**RE : Addendum Letter, Noise Feasibility Study  
Proposed Residential Development, Mount Hope Lands, Caledon, ON  
HGC Project #: 02400490**

As requested, HGC Noise Vibration Acoustics has prepared this addendum letter as an update to the latest noise report titled "Noise Feasibility Study, Proposed Residential Development, Mount Hope Lands, Caledon, Ontario" dated February 20, 2026.

Figure 1: Key Plan

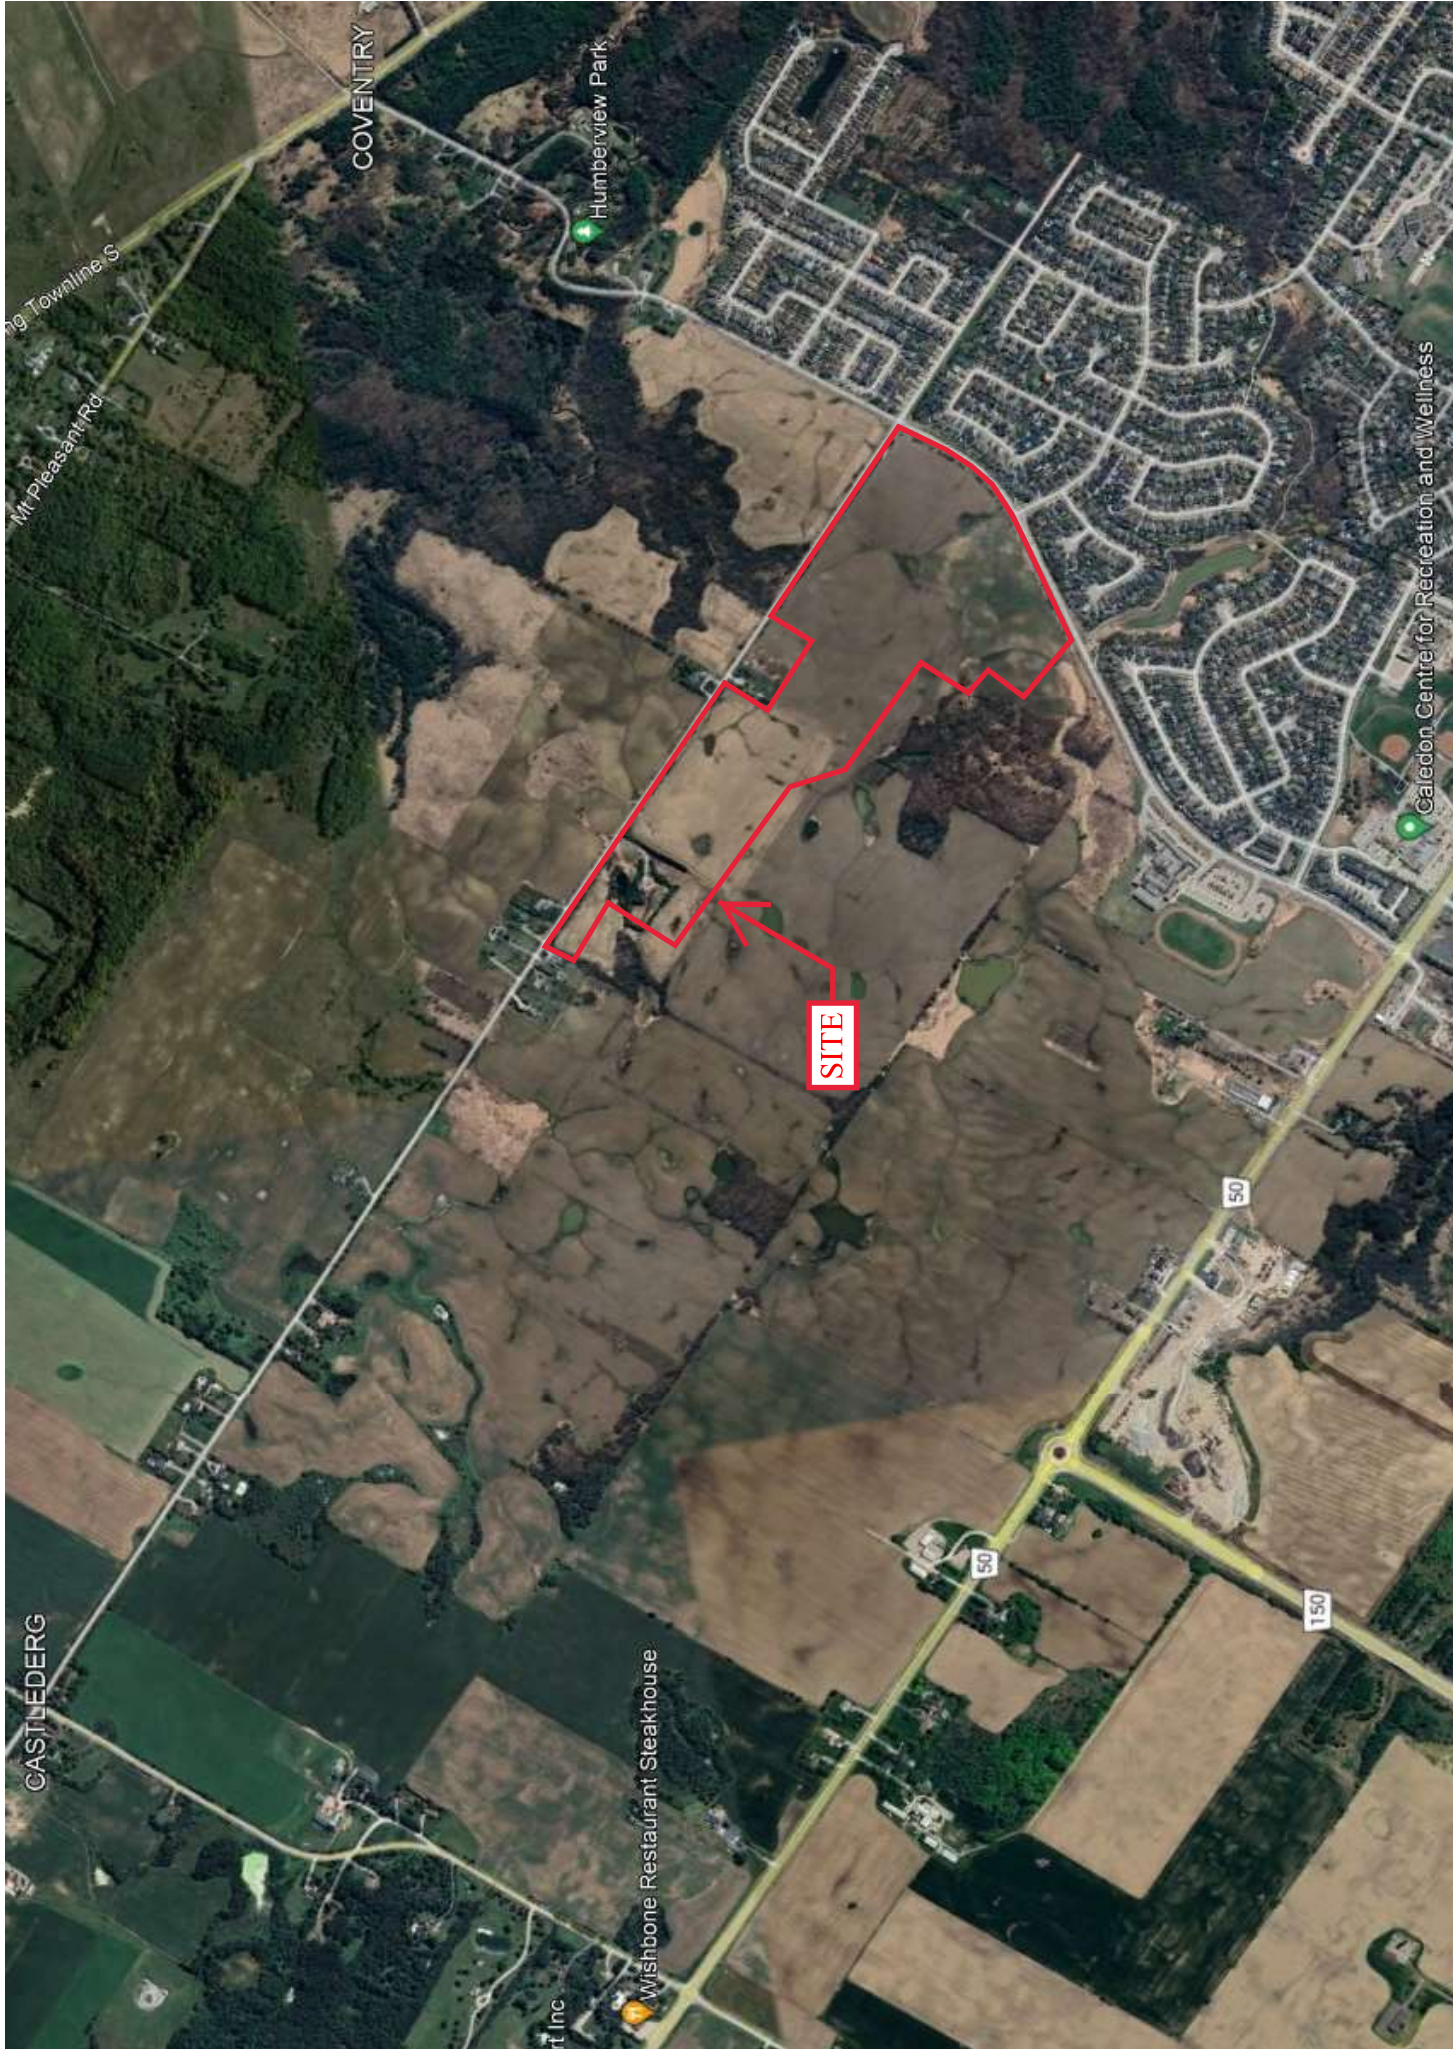
Since the completion of the Noise Feasibility Study, the concept plan has changed. An aerial imagery showing the site is attached as Figure 1. The current proposed development will consist of single detached dwellings, semi-detached dwellings, street townhouses, a commercial block, stormwater management pond, park blocks, and associated roadways. The latest concept plan dated, obtained on May 4, 2026, from Solmar personnel, is attached as Figure 2, indicating dwelling building setback locations. The proposed townhouse units are now located 5.0 m from the property line, adjacent to Mount Hope Road. Updated traffic noise assessment is provided below. The traffic noise criteria, site description and assessment methodology as outlined in the Noise Feasibility Study remain applicable.

Figure 2: Proposed Concept Plan Showing Prediction Locations

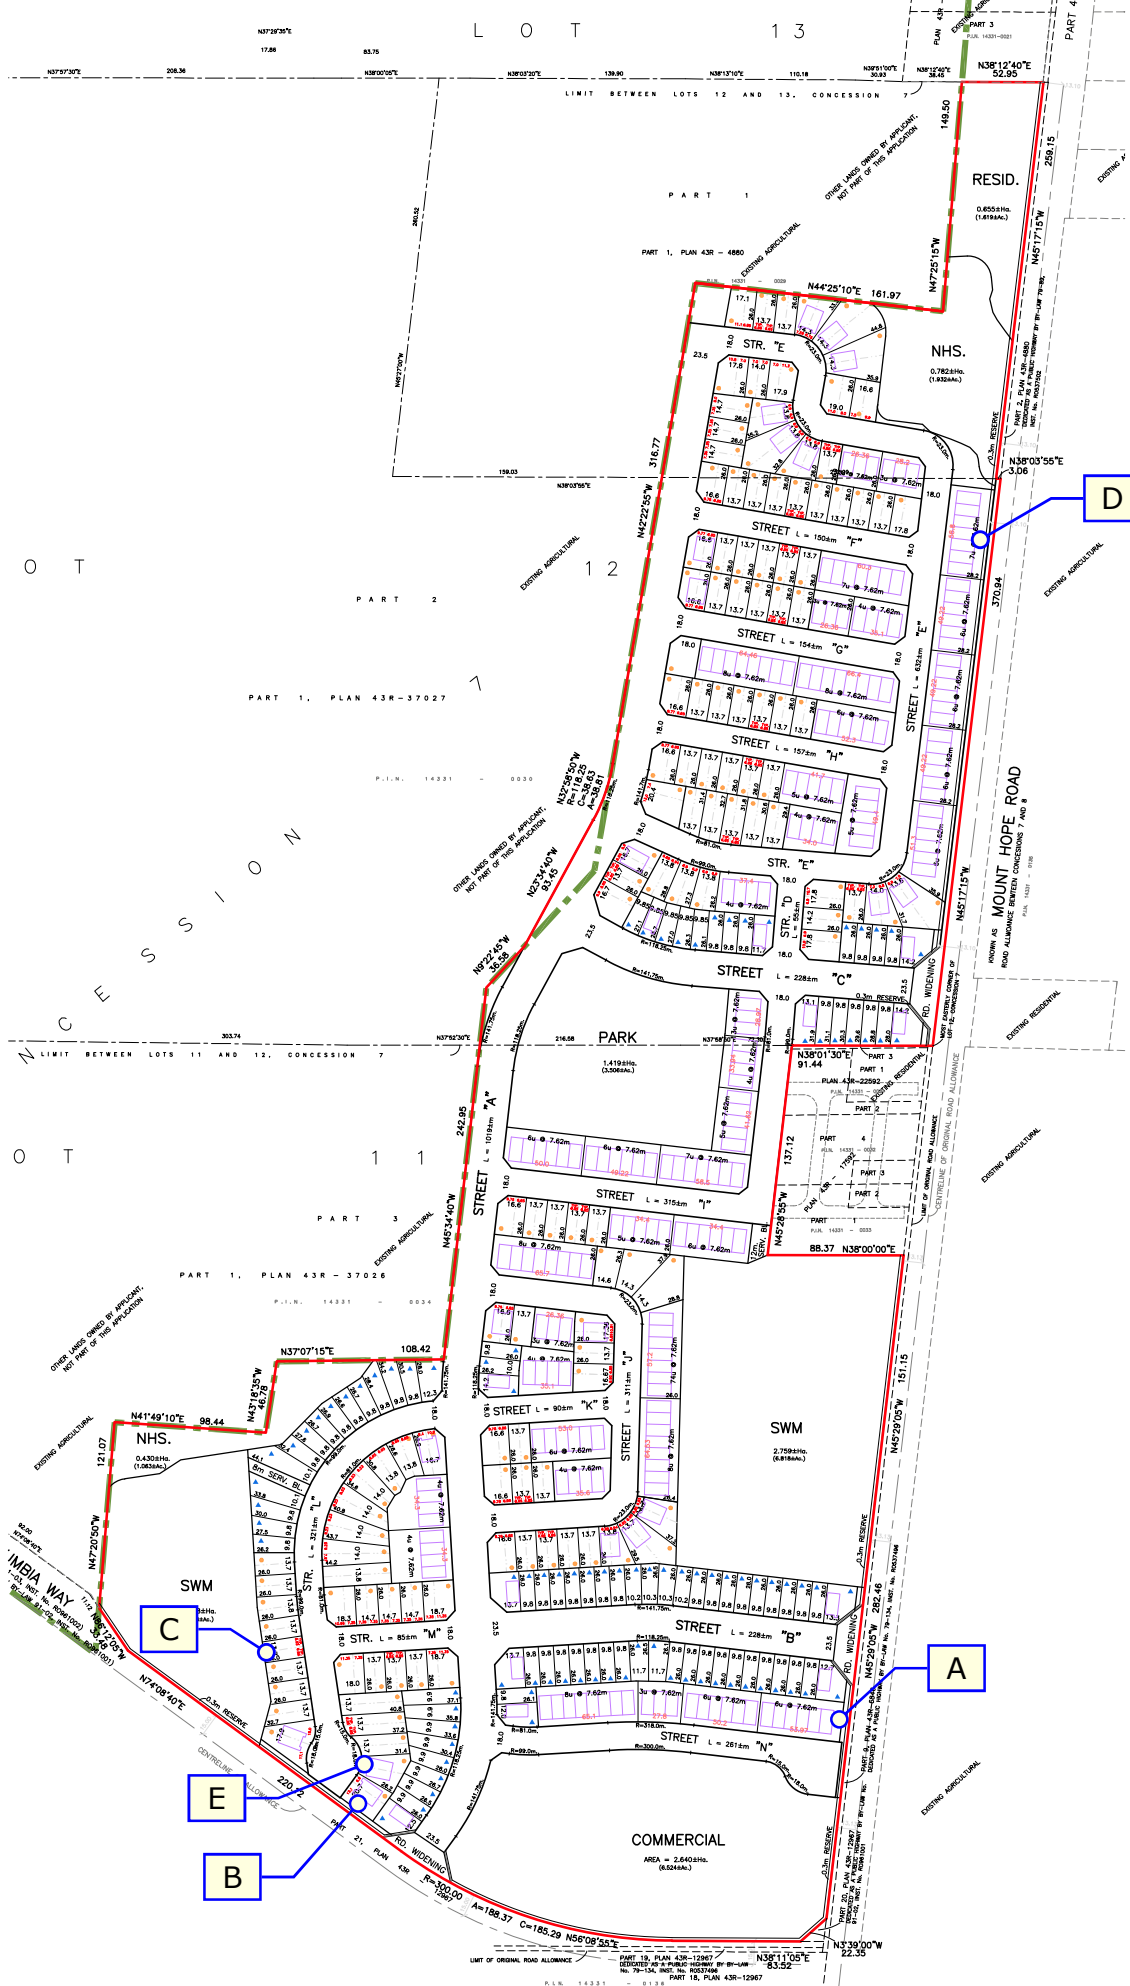
Prediction locations were chosen around the residential site, as shown in Figure 2, to obtain a good representation of the future sound levels at various dwellings. The results of these predictions are summarized in Table 2. The acoustic requirements may be subject to modifications if the site plan is changed significantly.

The predictions show that future traffic noise levels will exceed MECP guidelines at the façades closest to Mount Hope Road and Columbia Way. The updated dwelling setbacks result in a 1 dBA increase at prediction location [D], however, do not result in any additional recommendations beyond those in our previous report, which remain applicable. A summary of the recommendations is provided in Section 2.0.

Rear yard sound levels for dwellings exposed to Mount Hope Road and Columbia Road are predicted to be up to 62 dBA (prediction locations [A], [B], and [D]), exceeding the MECP limit of 55 dBA by up to 7 dBA and representing a 1 dBA increase from the previous report. To achieve 55 dBA, these dwellings require 1.8 m high acoustic barriers, consistent with our prior study.

Predicted sound levels in rear yards exposed to Mount Hope Road will be up to 62 dBA, 7 dBA in excess of the MECP limit of 55 dBA. Acoustic barriers of 1.8 m height are required for these dwellings to meet 55 dBA.
